**PLANNING DEPARTMENT ADMINISTRATIVE PUBLIC HEARING
SUMMIT COUNTY, UTAH
April 11, 2024**

- 1.A. **327 McHenry Avenue - Modification to Historic District Design Review Approval -**
The Applicant Proposes a Modification of the Historic District Design Review Approval for 327 McHenry Avenue's Landscaping plan to Include a Swimming Pool, Associated Mechanical Equipment, Retaining Walls, and Plantings. PL-23-05981 (Continued from March 28, 2024)
(A) Action
- 1.B. **1294 Rothwell Road - Administrative Conditional Use Permit -** The Applicant Proposes to Construct a Retaining Wall Over Six Feet in the Rear and Side Setbacks in the Recreation Commercial Zoning District. PL-24-06041
(A) Public Hearing; (B) Continuation to April 18, 2024

Subject: 327 McHenry Avenue
Application: PL-23-05981
Author: Caitlyn Tubbs, Sr. Preservation Planner
Date: April 11, 2024
Type of Item: Modification of Approval

Figure 1: Landscaping Plan Approved March 2, 2023

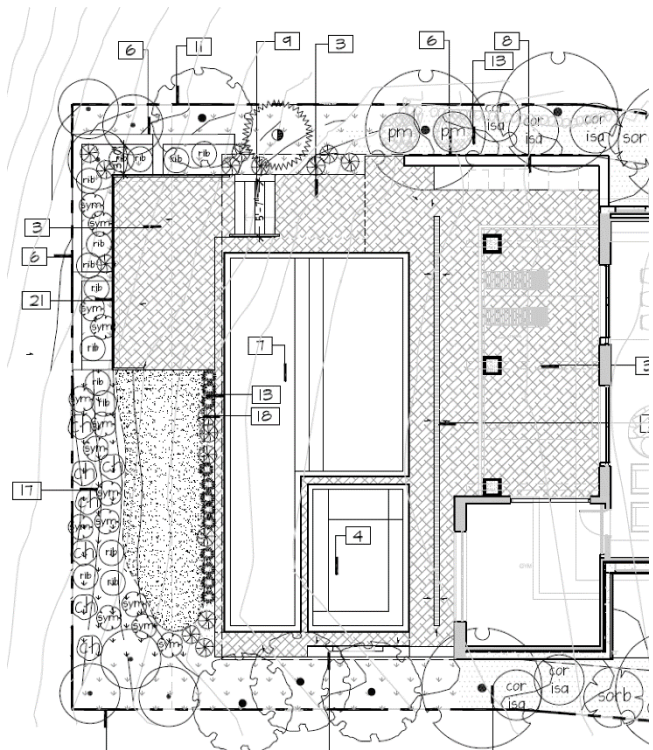
Following a public hearing held on March 2, 2023, the Planning Director conditionally approved a landscape plan that included a pool and hot tub with a combined size of approximately 37 feet by 20 feet (see Figure 1, right). Condition of Approval #1 of the Final Action Letter required the Applicant to obtain a Conditional Use Permit (CUP) for the swimming pool prior to obtaining a building permit for the pool installation.

During the March 2, 2023, public hearing, the Planning Director reiterated

landscapes in Historic Districts ideally return to a natural or original state, with minimal manipulation of the site (See Minutes, p. 8, Exhibit F). The approved modified landscape plan included three “levels”: the first contained the patio and proposed pool area, the second was a smaller patio that stepped down northwest toward the rear of the property, and the third was a lower level to the southwest of the pool that was to be a flat grassy area. These “levels” were to be retained by three concrete retaining planters filled with shrubs and grasses to obscure the concrete.

Figure 2: Proposed Landscaping Plan

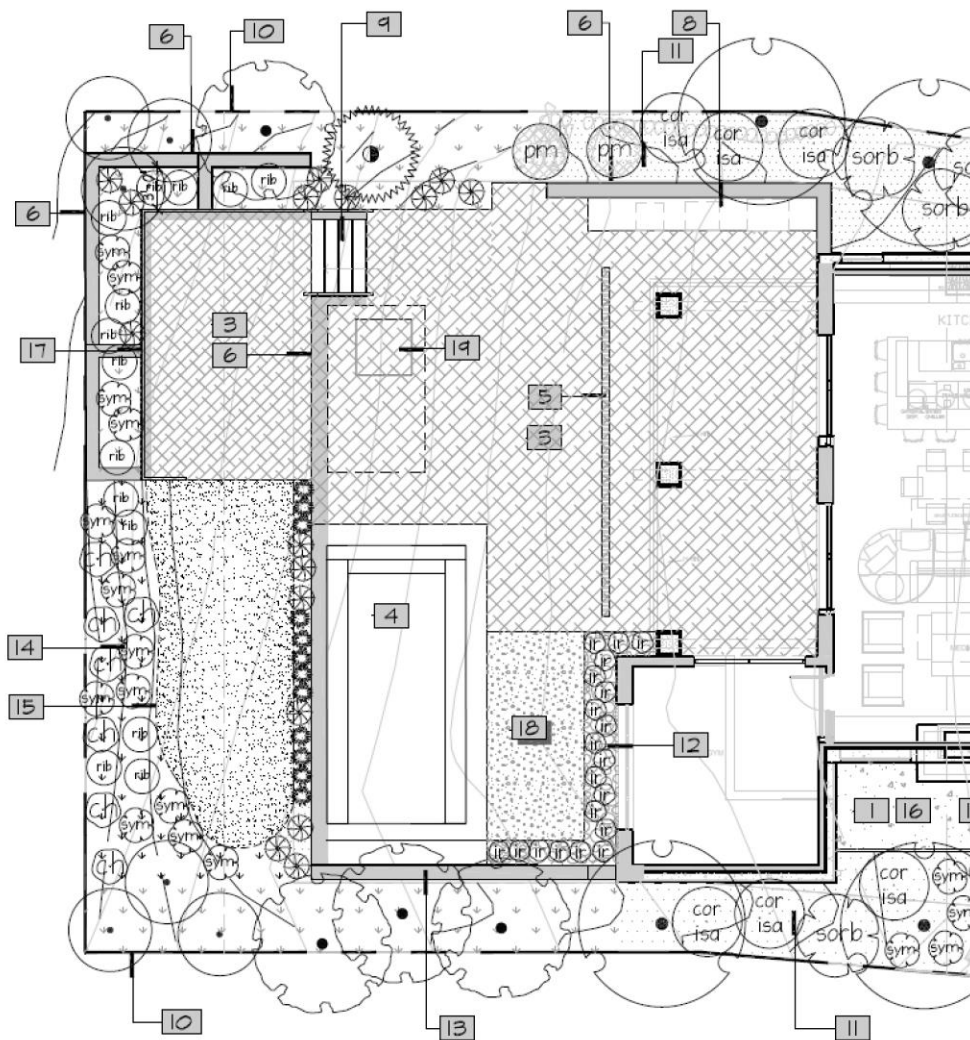
The current proposal is to modify this approved landscape plan by reducing the size of the swimming pool walls to accommodate additional plantings (See Figure 2, below). Additional trees and shrubs have been proposed in the perimeter of this area. The northwestern corner of the property would still have three four-foot-tall retaining walls that would be utilized as planters to obscure the concrete. The westernmost retaining wall would be located immediately adjacent to the rear property line and would not be obscured by plant materials.

Complies with Condition of Approval 6 – *The Applicant has proposed some grading of the property to facilitate an outdoor living area, pool, and patio. The Applicant has proposed to regrade the southwestern portion of the site to join up with the grade on the neighboring City property to the west. This would result in a vertical change from Existing Grade to Final Grade ranging between two and four feet in the southwestern ten-foot-deep corner of the property. Where the transitional patio meets the lower softscape area the proposed Final Grade is four to six feet above Existing Grade (elevation line 7216 is sited between existing elevation lines labeled 7210 and 7212) and must be adjusted so Final Grade does not exceed a four-foot vertical difference from Existing Grade (see Figure 3, next page).*

The northwest corner of the Lot is tiered to step up to the pool patio and includes a transitional patio between the pool area and the regraded softscape area. The Applicant proposes to visually soften and minimize the proposed retaining walls with planted shrubs, however, the placement of the lowest (westernmost) retaining wall is at the Property Line and no plantings are proposed on the adjoining property to screen this wall. The proposed retaining walls do not exceed four feet (4') in height within the required Setbacks and proposed Final Grade differs from Existing Grade by two to four feet. Park City Municipal owns the adjoining property to the west and will not permit the installation of these walls, or any structural elements thereof, on or within City property.

Complies with Condition of Approval 6 –*The proposed “flat” area will maintain the natural grade and will be planted with a water-wise sod and native seed mix. Condition of Approval #2 of the March 2, 2023 Final Action Letter prohibited the use of artificial turf on this property. The Applicant has proposed to regrade the southwestern portion of the site to join up with the grade on the neighboring City property to the west. This would result in a vertical change from Existing Grade to Final Grade ranging between two and four feet in the southwestern ten-foot-deep corner of the property. Where the transitional patio meets the lower softscape area the proposed Final Grade is four to six feet above Existing Grade (elevation line 7216 is sited between existing elevation lines labeled 7210 and 7212) and must be adjusted so Final Grade does not exceed a four-foot vertical difference from Existing Grade (see Figure 3).*

The Applicant has proposed a retaining wall to hold the swimming pool and patio area as well as a stepped retaining wall at the northern corner of the property to facilitate a lower patio on the property. The retaining walls will include planting areas with a three-foot depth to provide an opportunity to screen the concrete retaining structure from view with grasses and shrubs. The westernmost retaining wall is set immediately adjacent to the western property line and would be minimally screened by existing vegetation on the neighboring property. However, the placement of the lowest (westernmost) retaining wall is at the Property Line and no plantings are proposed on the adjoining property to screen this wall. The proposed retaining walls do not exceed four feet (4') in height within the required Setbacks. Park City Municipal owns the adjoining property to the west and will not permit the installation of these walls, or any structural elements thereof, on or within City property.

6. Final Grade shall be within four vertical feet of Existing Grade.

Figure 1: Applicant's Site Plan Indicating Location of Chiller Unit

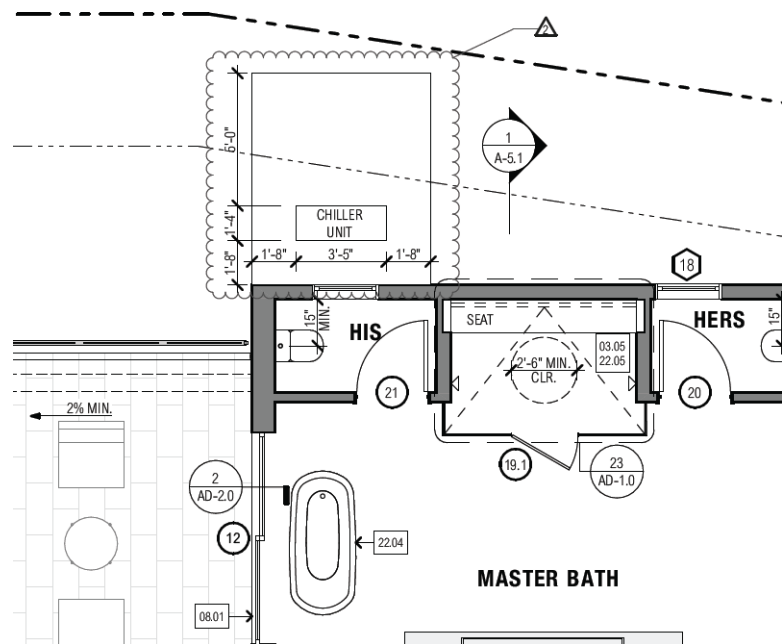
The subject property is located within the Historic Residential Low-Density (HRL) Zoning District. Pursuant to LMC [§15-2.1-3 – Lot and Site Requirements](#), mechanical equipment must be located at least 3 feet from a Side Lot Line and must be screened. The Applicant has proposed locating a chiller unit adjacent to the Master Bathroom; it will be sited 5 feet from the northern Side Lot Line.

Section [§15-13-8](#) of the Land Management Code outlines the design standards for new infill construction in historic districts. Because this modification request is specifically focused on siding and mechanical equipment this section will focus on those items.
